**SUBJECT: Addendum No. 1**

**REFERENCE: Invitation To Bid (ITB) for William P. Hobby Airport Central Concourse Flooring Replacement Phase II; Solicitation No. HHG-HOUCCF-2023-010; Project No. 957.**

**ADDENDUM NO. 1 (Revised Drawings)**

**HOU CENTRAL CONCOURSE FLOORING REPLACEMENT – PHASE II**  
**HOBBY P. WILLIAM AIRPORT**

04 EAST ELEVATOR LOBBY  
1/4" = 1'-0"

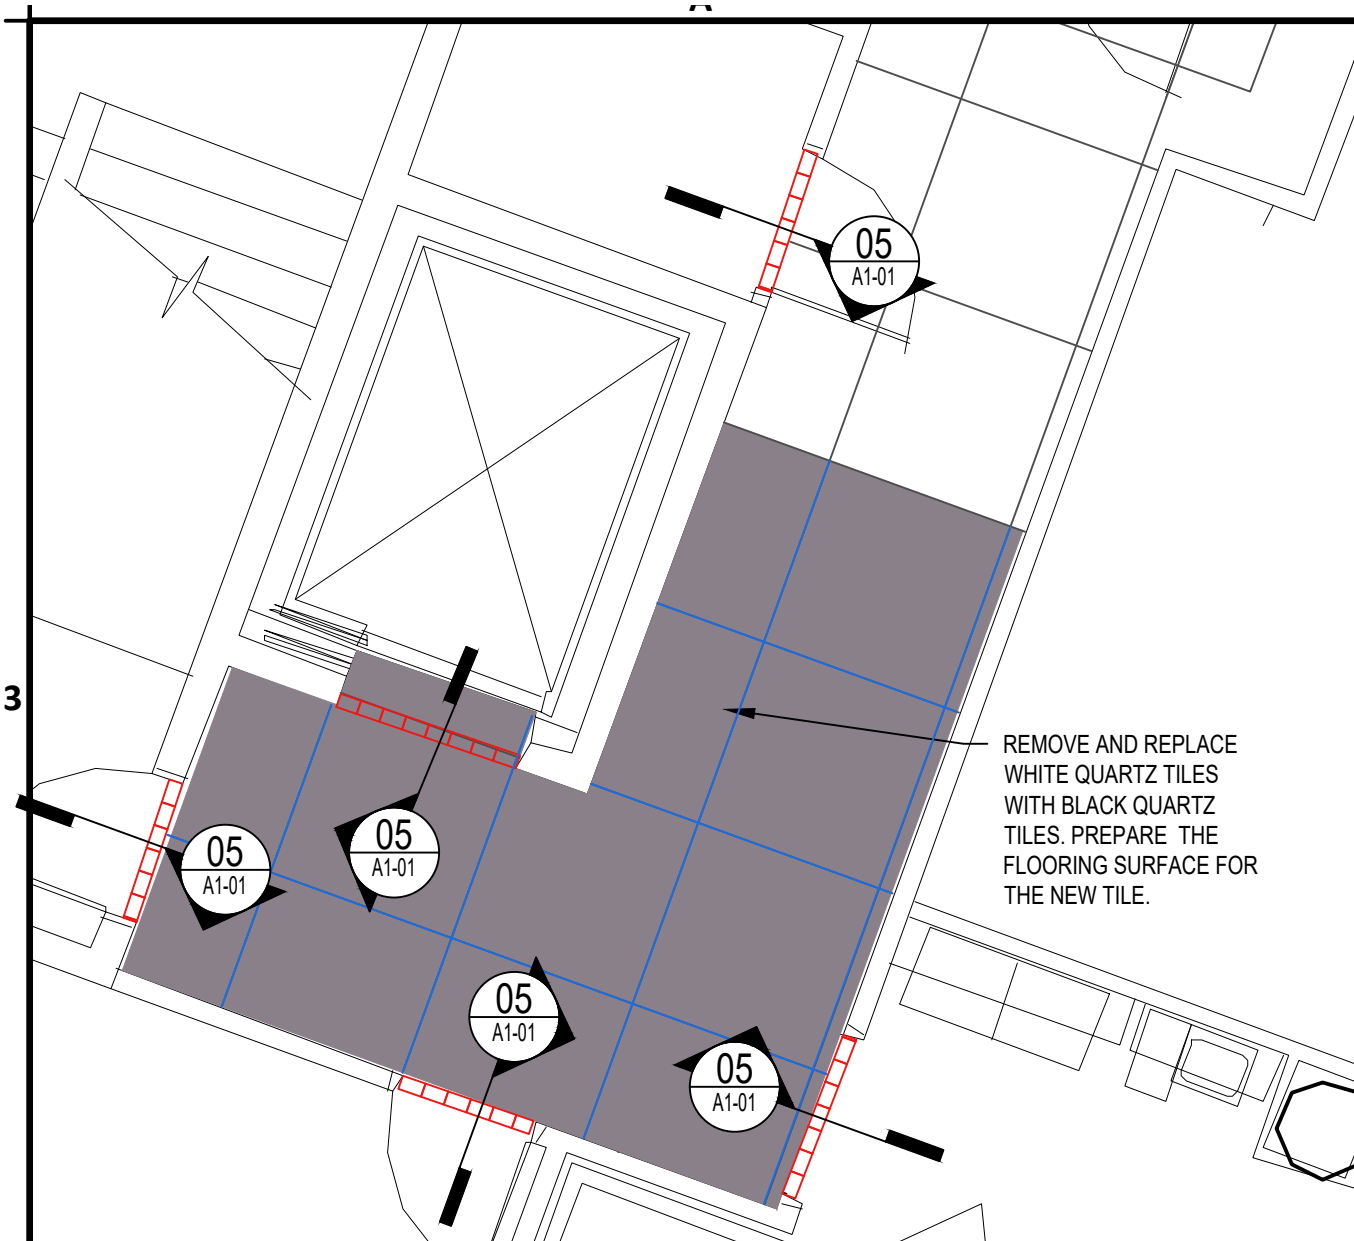
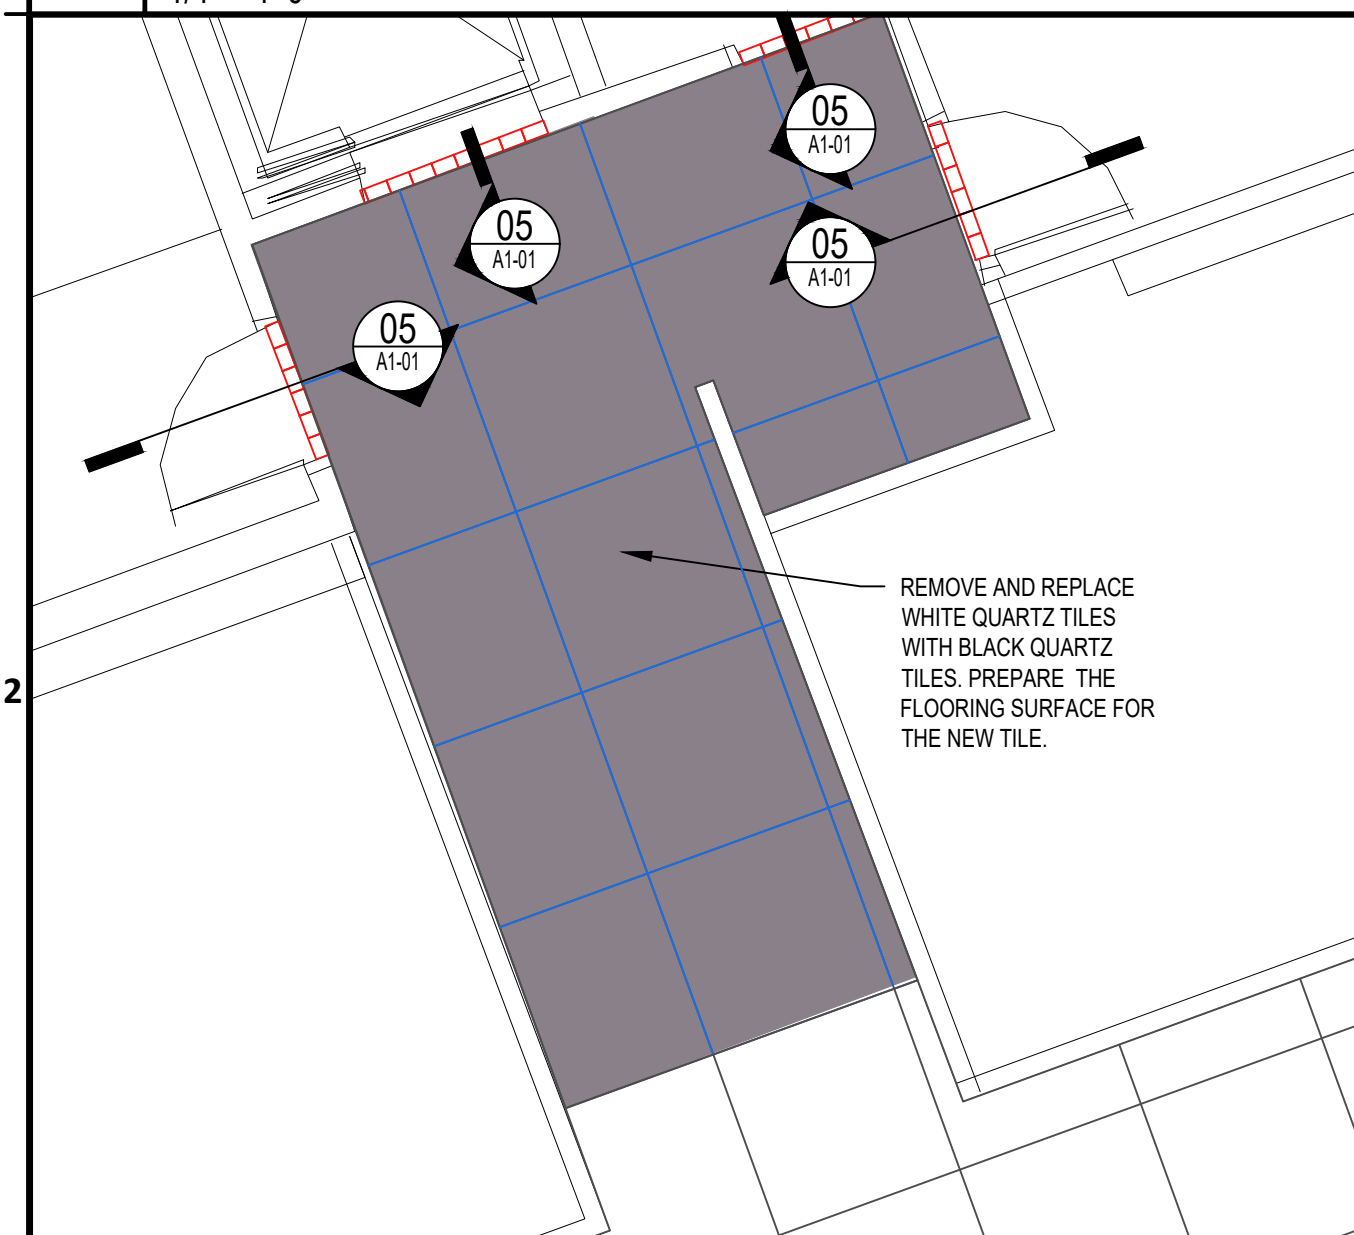
19. **Question:** Will the elevator lobbies outlined on page A1-01 need the same tile installed as scheduled in the main area? T1?

**Response:** As shown on 02/A1-01, a portion of the existing white tile in this area will be replaced with the T4 black diamond tile. Per detail 04/A1-01, Contractor will prep the floor to receive the T4 black diamond tile in the area indicated; however, the remaining flooring in the hallway is to be T1 Perla Blanco.

01 OVERALL SOUTH CONCOURSE PLAN  
1" = 50'-0"

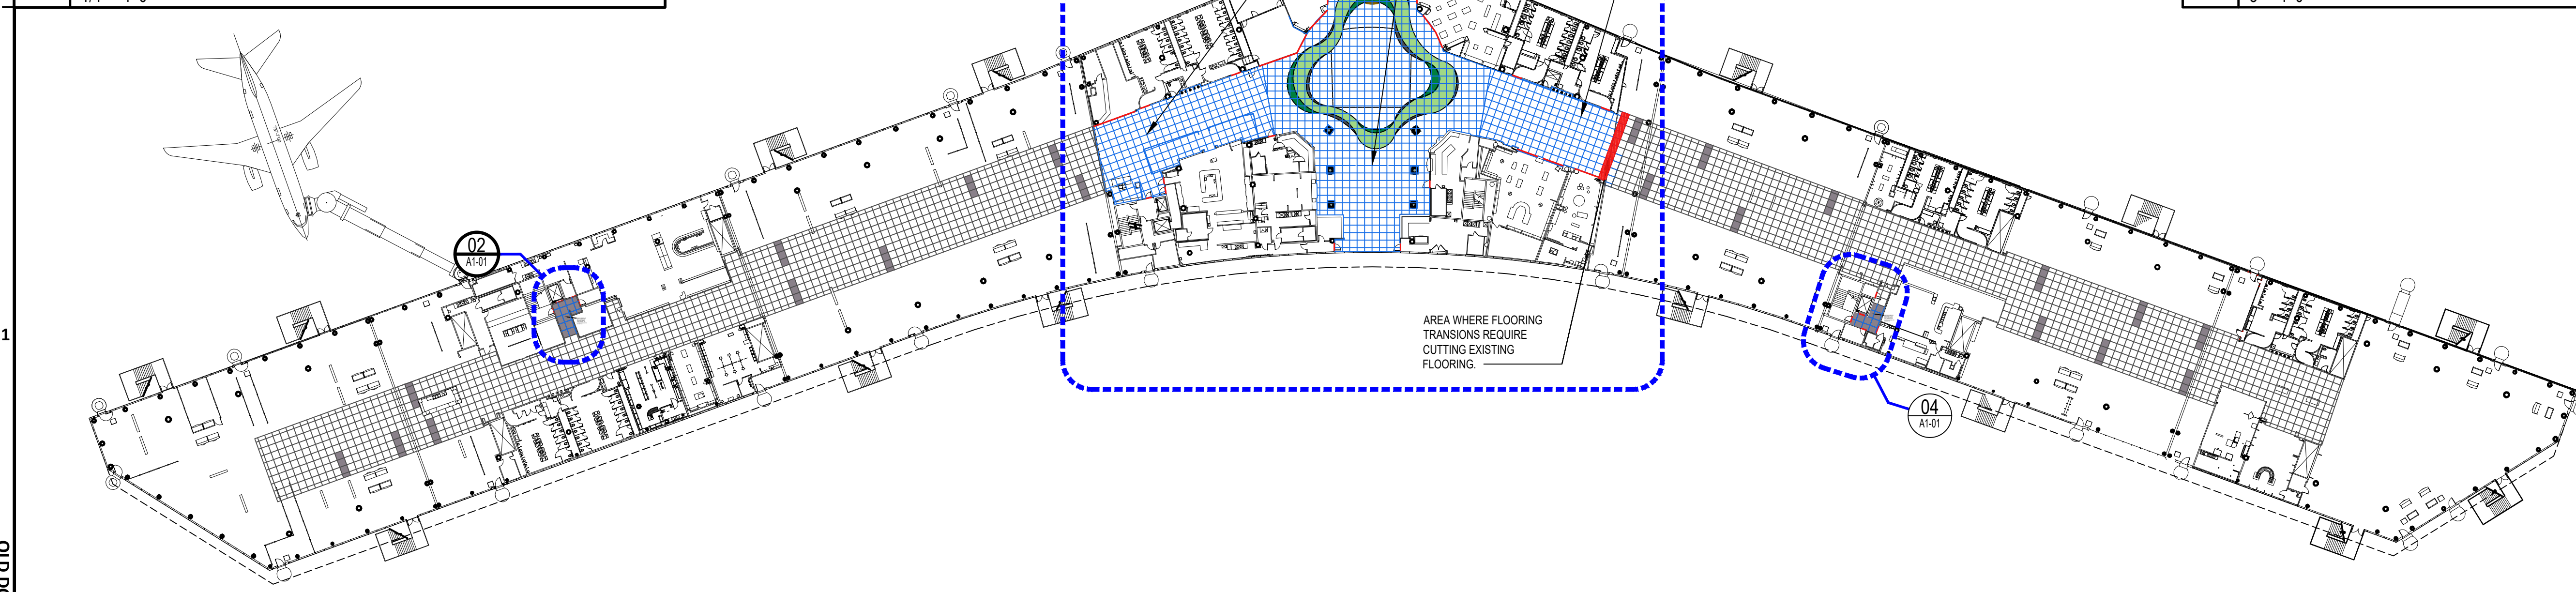
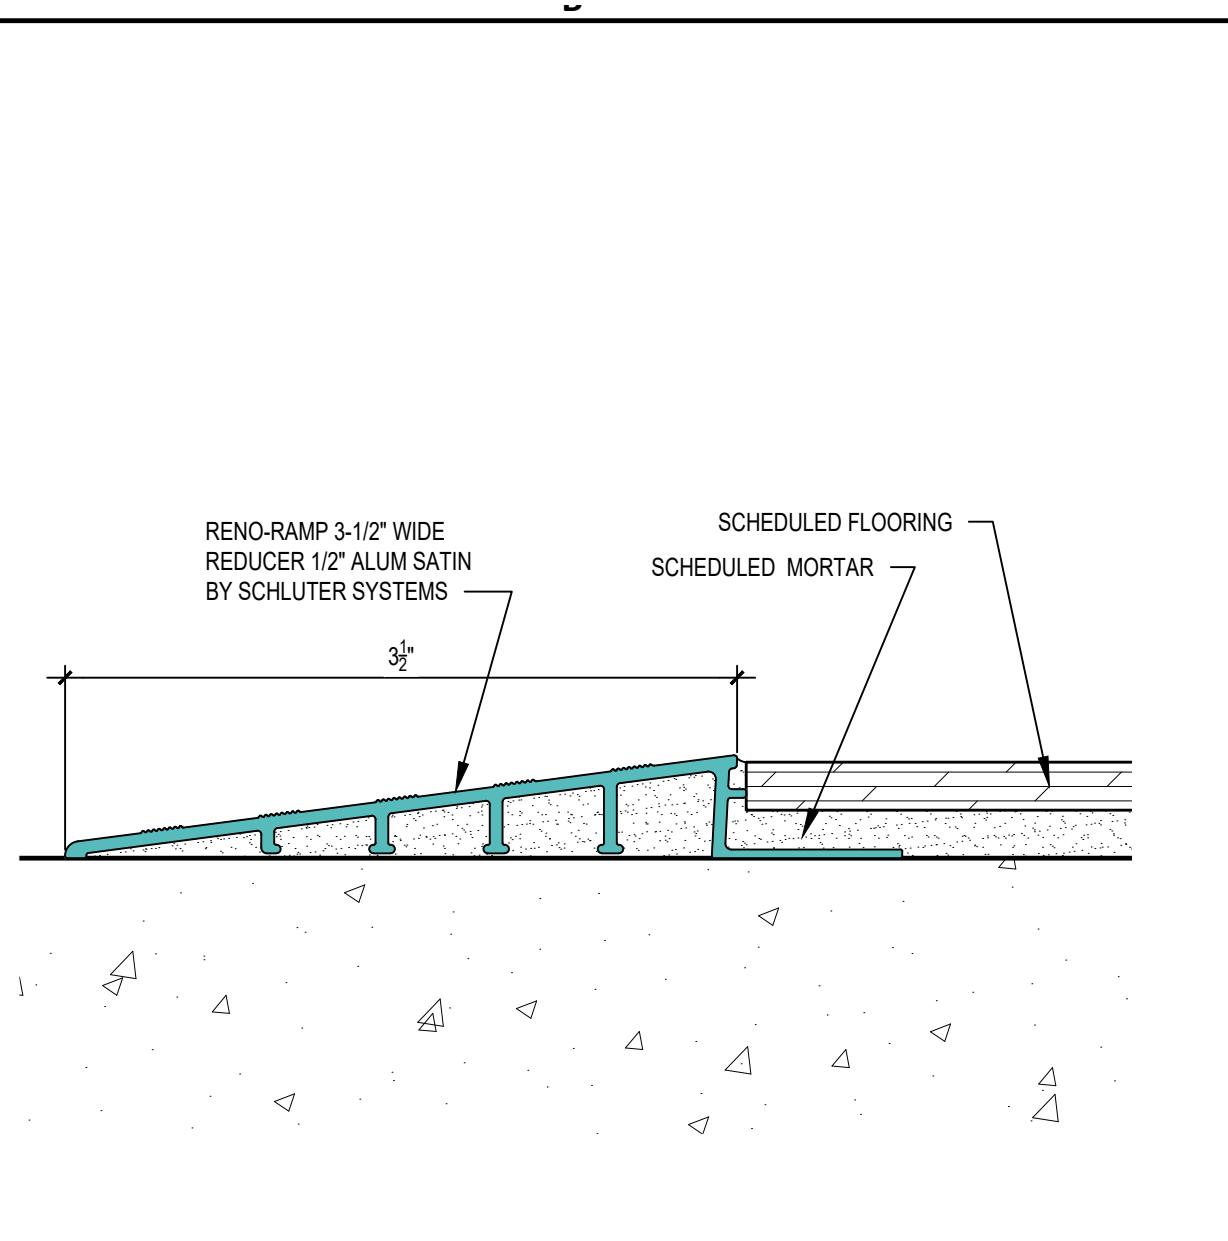
20. **Question:** Are the reno ramp transitions the borders marked in red on Page A1-01?

**Response:** Yes, the red marking on the floor plan represents the transition between the new tile and the existing floor material. These intersections are called out on Sheets A2-01 C, A3-01, A3-03.

06 TILE FLUSH TRANSITION DETAIL  
1:1

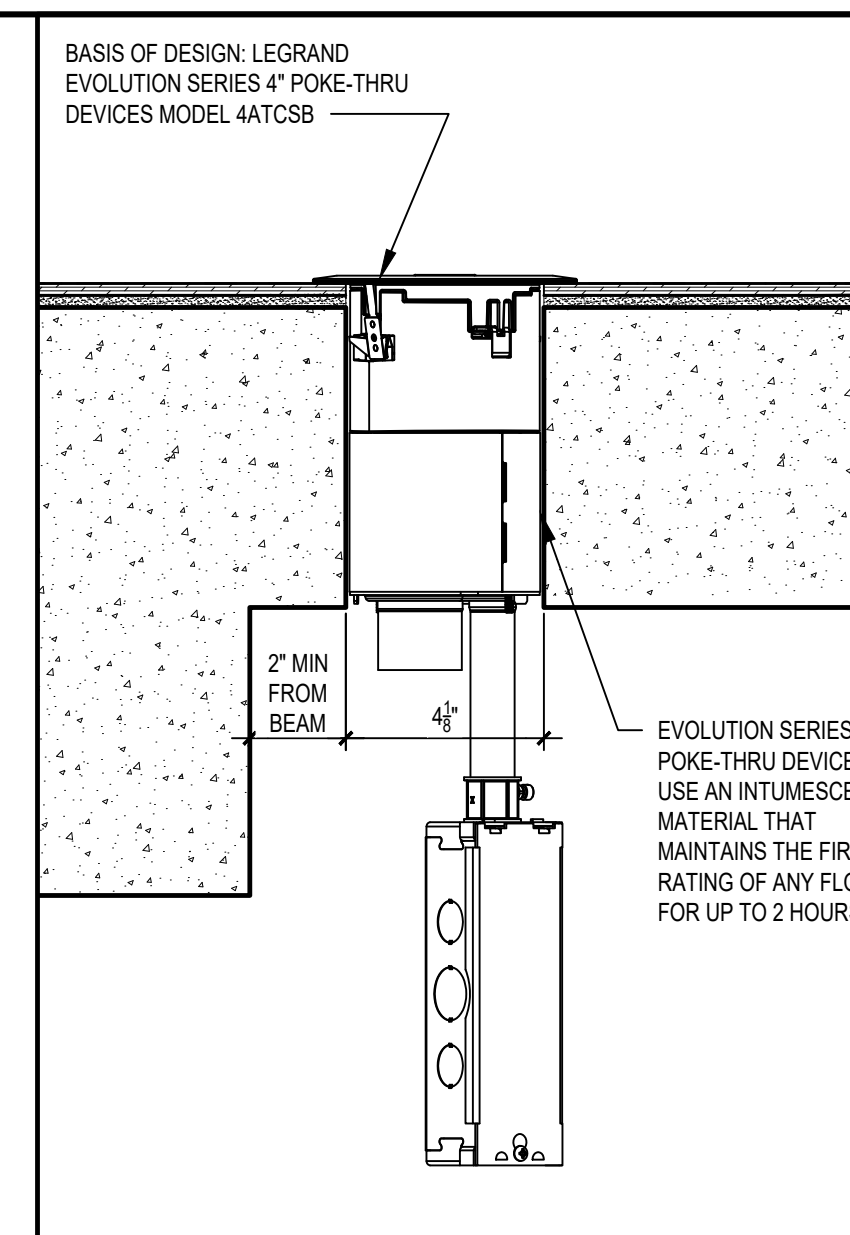
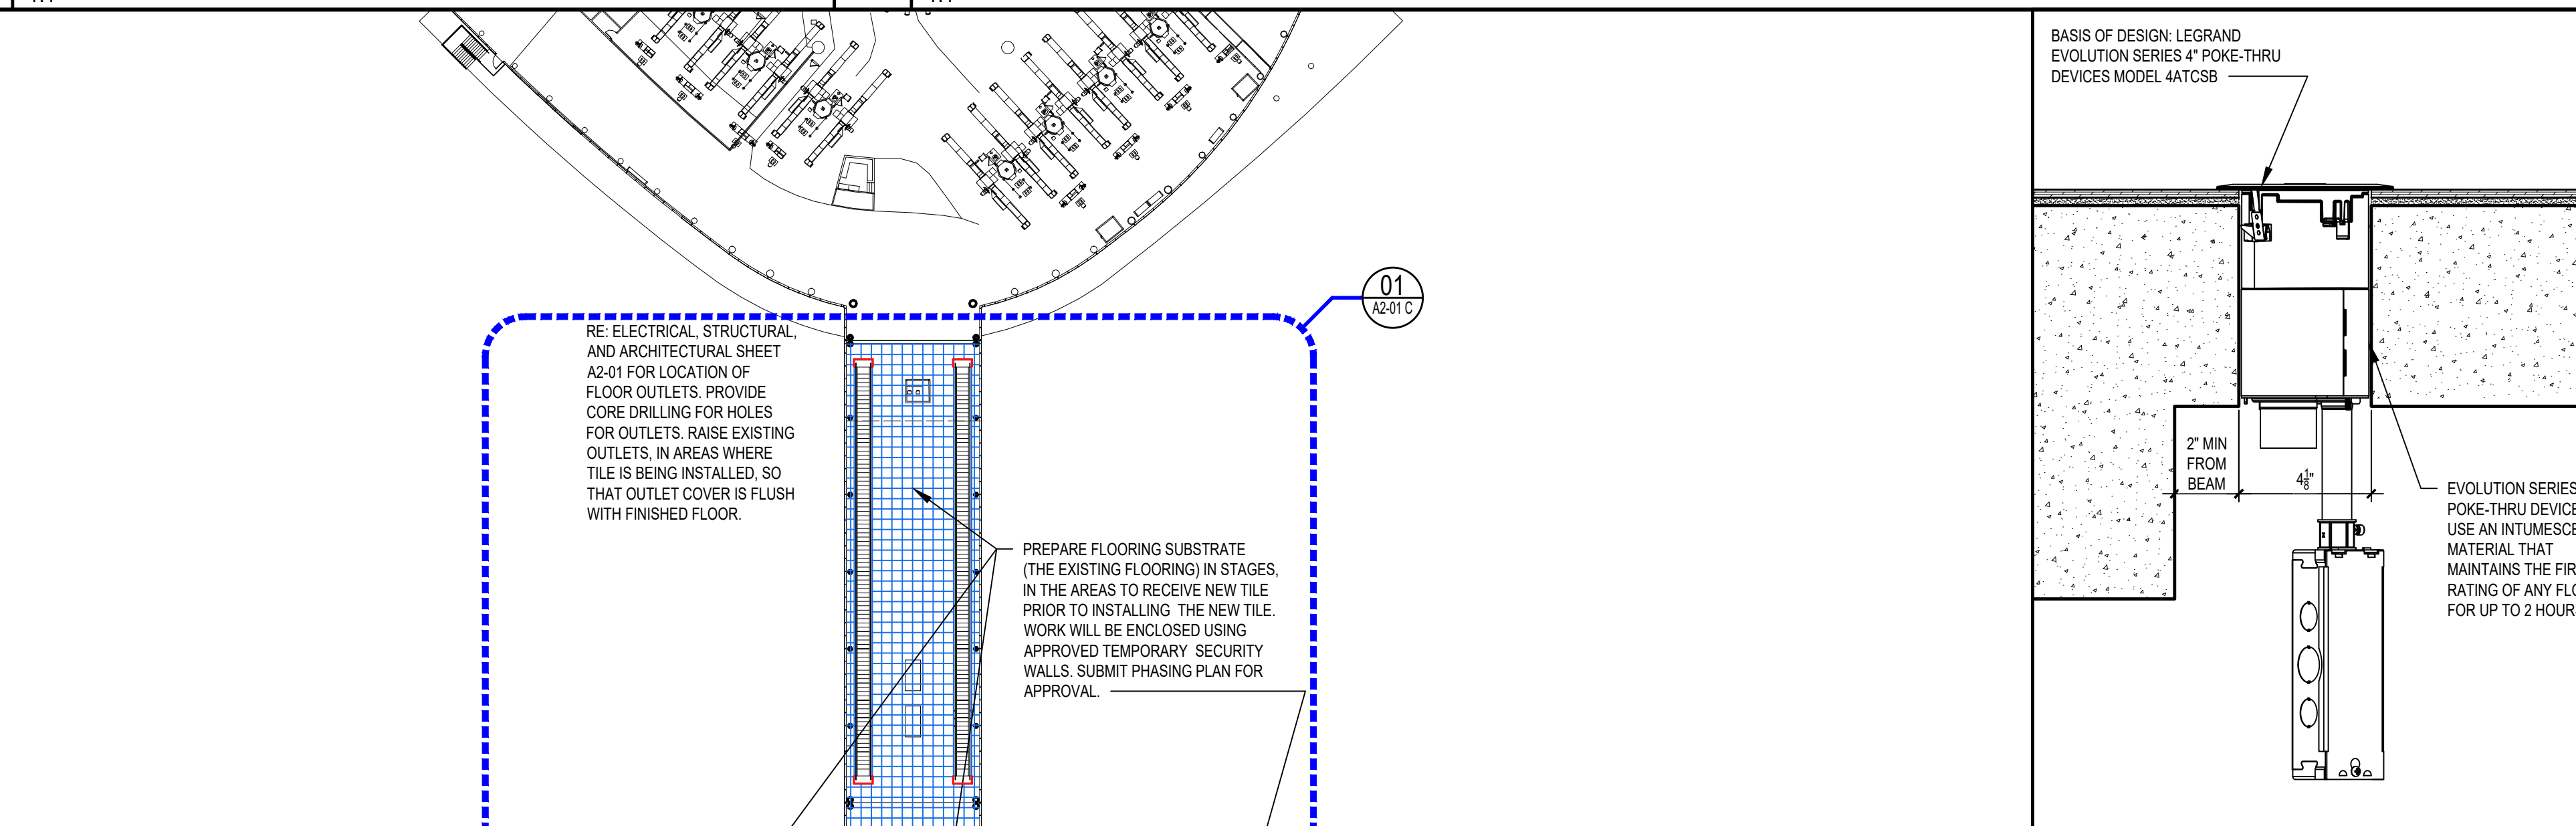
9. **Question:** Plans call to grind the edges back 24" – will cut tiles be allowed on edges?

- 3.1 Sheet G100 - Cover Sheet:
  - A. Modified date to include Addendum No. 1 date.
- 3.2 Sheet G110 - Index Sheet:
  - A. Modified dates on Index to include Addendum 01.
- 3.3 Sheet A1-01 - Overall South Concourse Plan:
  - A. Modified Detail 06.
- 3.4 Sheet A2-01C - Overall Finish Floor Plan:
  - A. Modified transition detail at end of people mover. See Detail 05/A1-01. Added note at Information Booth.
- 3.5 Sheet A3-01 - Enlarged Floor Plan Areas B& C:
  - A. Modified floor transition strip to restroom entrances. Added note for stainless steel base scope.
- 3.6 Sheet A3-03 - Enlarged Floor Plan Area A:
  - A. Modified floor transition strip to restroom entrances. Added note for stainless steel base scope.
- 3.7 Sheet A4-04 and A4-05 - Dimensional Control Plans D&E:
  - A. Modified existing column wrap locations.

**Response:** The grinding of the floor to allow tile to be flush with adjacent floor plane will take place at the east side transition of old tile to new tile, all other transitions shall be with a metal transition edge. Refer to Details 05 and 06 on Sheet A1-01. The drawings have been modified and issued with Addendum 001 showing this condition. Contractor will provide a mock-up of these conditions for approval by architect and HAS prior to proceeding to full installation.
